**First Congregational Church
Nantucket, MA
Exterior Tower Repairs, Restoration and Conservation**

Study photos

August 22, 2007

**DMH Enterprises, Architects
104 Federal Street
Salem, MA 01970
617-745-2172**

Second page of George Wrenn memo of 1968 - assumed to be this data as he refers to Graves design. Discusses design of spire and steeple.

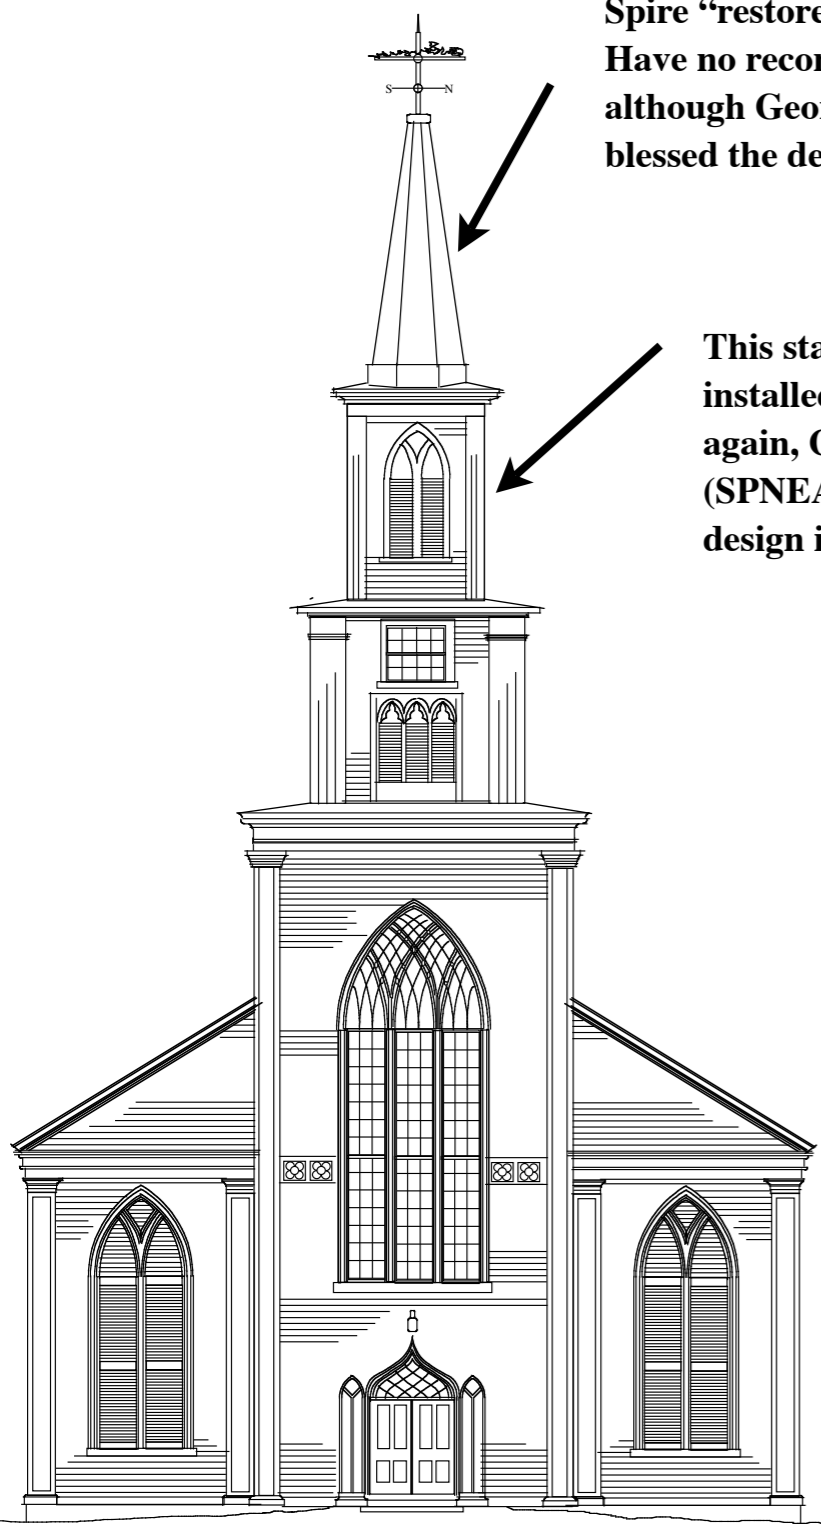
Following are some comments on the drawings and specifications prepared by Mr. Graves for the restoration of the Congregational Church. These comments pertain only to those portions of the drawings and specifications which apply to the historical architectural aspects of the building.

- I. Effect of new structural members on the appearance of the interior of the auditorium: The new 8" diameter columns are of such size that they necessitate breaking through the back wall of the auditorium at each corner and constructing a new section of wall. Careful investigation should be made by the structural engineer to determine whether it might not be possible to use a column of rectangular outline which might fit within the 6 1/2" wall and avoid the necessity of breaking through the old walls.

- II. Wall treatment: I feel that the removal of the existing plaster and the installation of sheetrock is going to create a wall which is too perfect and which will never have the slight imperfections of surface and age which plaster on wood lath has by nature and acquires with the years. One of the real problems raised in the course of every restoration is that our techniques allow the work to be done better than it had been done. Use of these techniques means that we cannot achieve the effect which was achieved in the past and it seems to me unfortunate to use them where early plaster still exists, albeit with some cracks in it.

- III. Ceiling treatment: I like the idea of preserving the old plaster ceiling under the new and don't object to the use of sheetrock here. Unless there is good reason to remove the plaster rosette in the center of the ceiling, I think that it should be preserved intact.

- IV. Lighting of the auditorium: Wall sconces were never used in the auditorium and their use should not be considered. I have yet to see any evidence that a chandelier was ever used in the auditorium either and until such evidence is found I don't think that the use of a chandelier should be considered either. The church and auditorium are fine enough architecturally themselves to stand without being dressed up in a way which never existed. If extra light is thought necessary it is preferable to get that light through unobstrusive modern spot lighting perhaps located in the choir loft and reflecting off the ceiling. I am uncertain as to what

lighting arrangement is proposed at the pulpit so will withhold comments at the present time.

- V. Tower and steeple: I think that the steeple should be made as tall as possible within the scope of the present drawings in order to counteract the foreshortening effect of looking up at it from the ground. Also, the point should be made as pointed as practicable considering the installation of a weather vane on top of it. The general design is good and the rail along the roof of one level of the tower is a good idea. Its exact design will need careful study. I'm inclined to be against moving the present finials to a higher level. Perhaps it would be better to put another set of finials at the higher levels of similar design to those below. This design, of course, will be determined by what is found under the present covering of the finials. Finally, the new sash should match the sash shown in the old photographs.

- VI. Exterior surface treatment: The shingles now in place over the old clapboards should be removed and the clapboards should be preserved in place where their condition warrants. Paint colors remain to be determined.

East - can justify this set

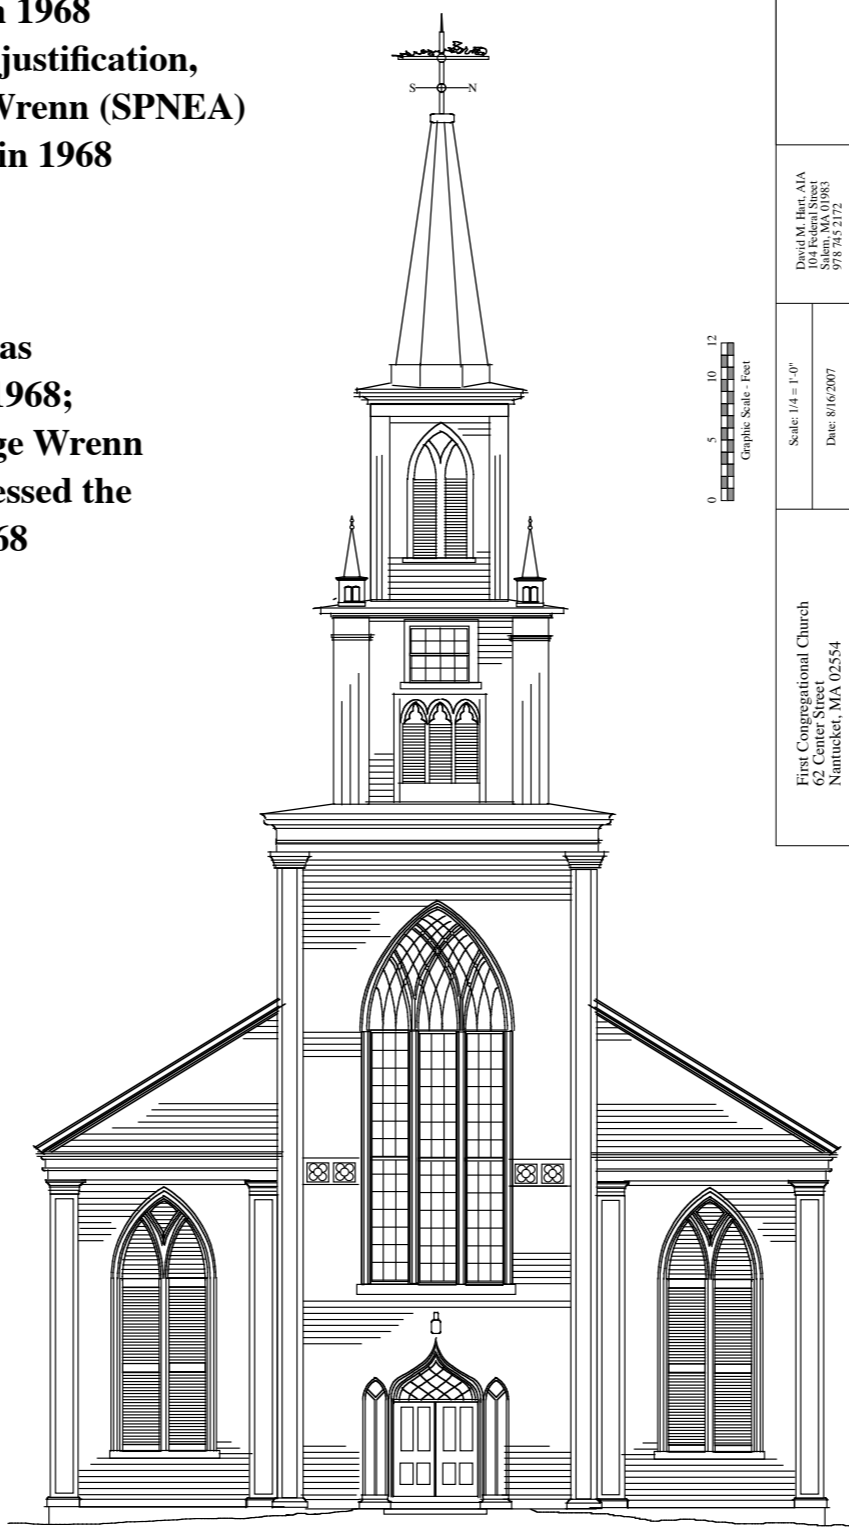
**Spire "restored" in 1968
Have no record of justification,
although George Wrenn (SPNEA)
blessed the design in 1968**

**This stage was
installed in 1968;
again, George Wrenn
(SPNEA) blessed the
design in 1968**

**East - have no
documentation for the
second set**

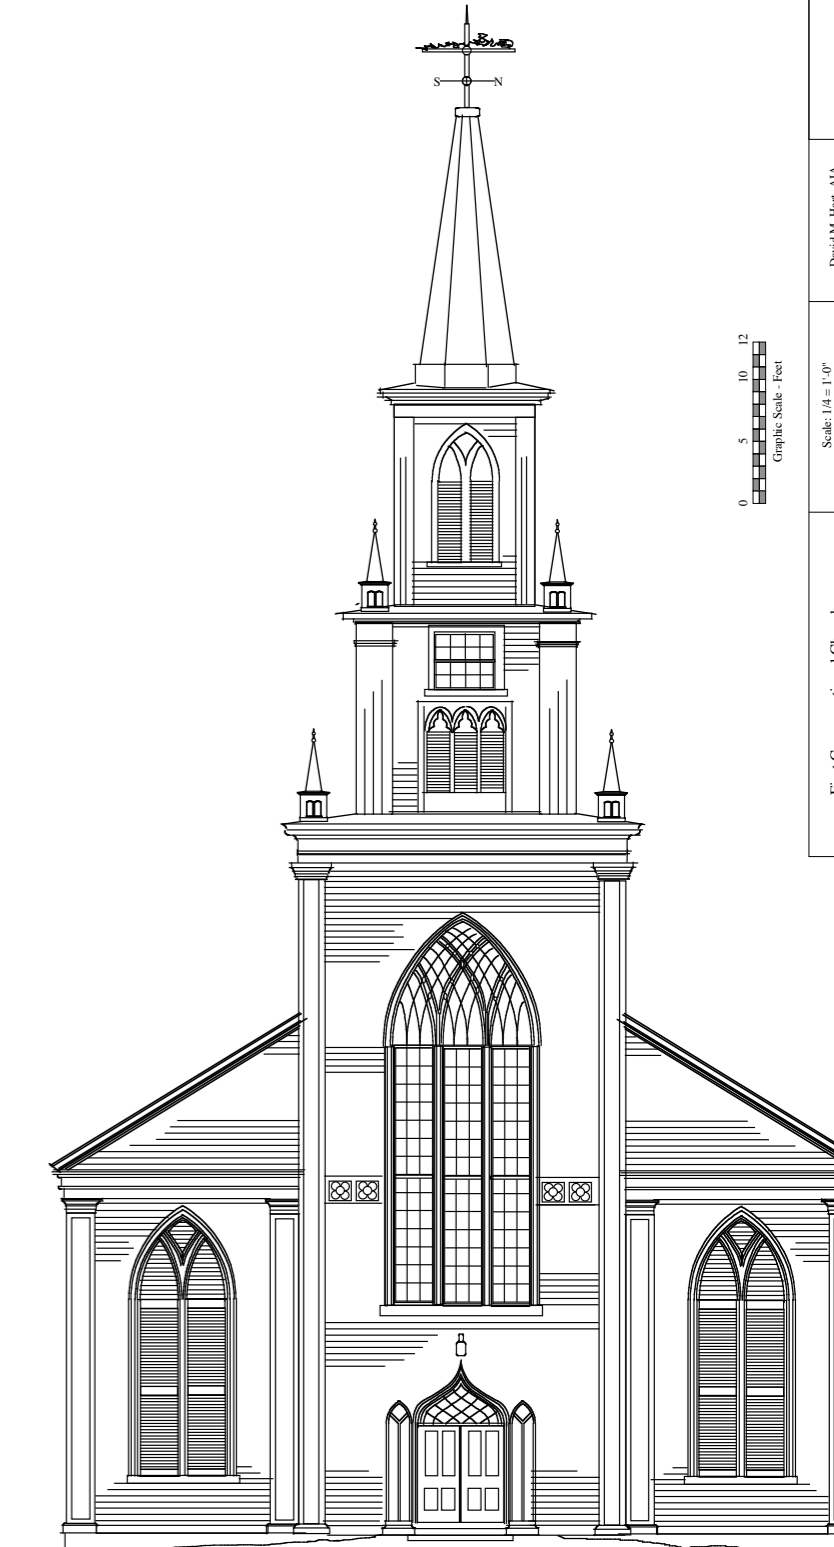
Questions:

- 1. Can the lower set of finials be justified based upon historic precedent?**
- 2. Does the upper stage (below the spire) have any historic precedent?**
- 3. Does the spire have any historic precedent?**
